GNRO-2012/00089

SUBJECT: Response to Request for Additional Information (RAI) Set 27 dated July 17, 2012
Grand Gulf Nuclear Station, Unit 1
Docket No. 50-416
License No. NPF-29

Response to Request for Additional Information (RAI)

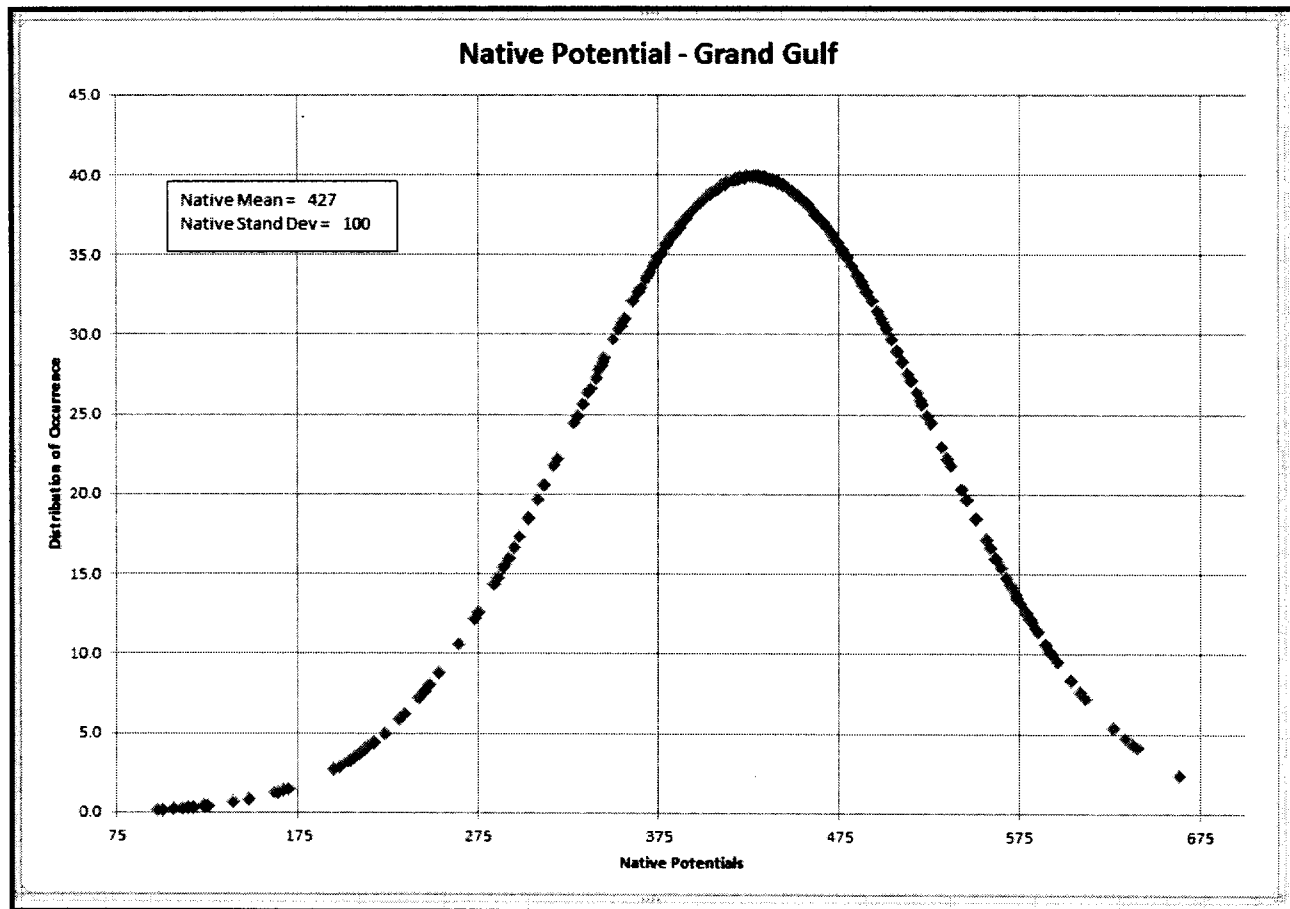
The response was insufficient in demonstrating that the most active (e.g., most anodic) buried in-scope piping material has achieved a 100 mV polarization in that it did not address the mixed metal environment of the buried piping. For example, the following was not provided:

- evidence or proposed future evidence (e.g., buried test coupons) to ensure that 100 mV criterion was providing sufficient protection for the mixed metal environment as defined previously,
- evidence that even while utilizing a 100 mV criterion, local soil-to-pipe potential were close to -850 mV, or
- the basis for using the 100 mV criterion.

Request. In light of the in-scope buried piping being within a mixed metal environment:

- a. State why a 100 mV polarization is adequate to protect steel and stainless steel buried components when there is a nearby bare wire copper grid.
- b. If a 100 mV polarization criterion cannot be demonstrated to provide adequate protection to the piping, propose and provide the basis for an alternative criterion.
- c. Describe the testing methodology which verifies adequate level of polarization for the steel and stainless steel buried piping.

- a. A three part response provides the necessary evidence that the 100mV polarization criterion is adequate to protect the steel and stainless steel buried components.

- 1) When establishing criteria for cathodic protection, NACE Corrosion Engineer's Reference Handbook specifies for Steel and Cast Iron "... A minimum of 100mV of cathodic protection between the structure and a stable reference anode." For Copper, the handbook specifies "A minimum of 100mV of cathodic protection between the structure and a stable reference anode." This guidance confirms that the criterion of 100mV polarization is adequate to protect both steel and copper, and with the CP system raising the piping and grounding grid to an equipotential voltage of 100mV, galvanic action is nullified.

- 2) For the design of a CP system, the NACE Corrosion Engineer's Reference Handbook specifies that a target current density of 0.1 mA/ft² to 0.2 mA/ft² should be applied to the system to ensure adequate protection. The protected area at GGNS is approximately 22.175 acres, and the applied current from all rectifier units was last measured at 214.65 amperes giving an average current density of 9.68 amperes per acre or 0.2 mA/ft² which meets the target current density specified above and confirms that adequate protection is being provided to the affected structures by the 100mV criteria.

- 3) If the piping was near bare wire copper grounding grid cable, there would be a general reduction of the overall half-cell potential of steel from the couple with the copper. This would be apparent in a plot of native potential data that would show the mean for the plot being close to 350 mV. As shown on the figure below, this is not the case at GGNS as the mean is 427mV which provides evidence that piping is not near bare wire copper grounding grids or mixed metal couples that would affect the ability of the 100 mV polarization to protect the piping.

- b. As noted in (a.) above, the 100mV polarization criteria has been demonstrated to provide adequate protection to the buried piping.
- c. The method used at GGNS to verify an adequate level of polarization of the buried piping is an area potential and earth current (APEC) survey. In this process, a computer based data logger is used to collect Cu/CuSO₄ reference cell potentials at various areas of the plant, while at the same time dual earth current voltage gradients are collected in a rectangular co-ordinate "normal" X-Y grid. After processing, this APEC data is integrated for evaluation into a geographic information system (GIS) in relation to the location of all buried plant assets. The APEC survey provides an extensive data set that enables this specialized indirect inspection survey method to provide the information necessary to 1) define significantly active corrosion cells, 2) determine the plant piping coating condition, and 3) evaluate the performance of all influencing CP systems from a detailed graphical representation. The information provided by the APEC survey as discussed above ensures that an adequate level of polarization is achieved for the carbon steel and stainless steel buried components.
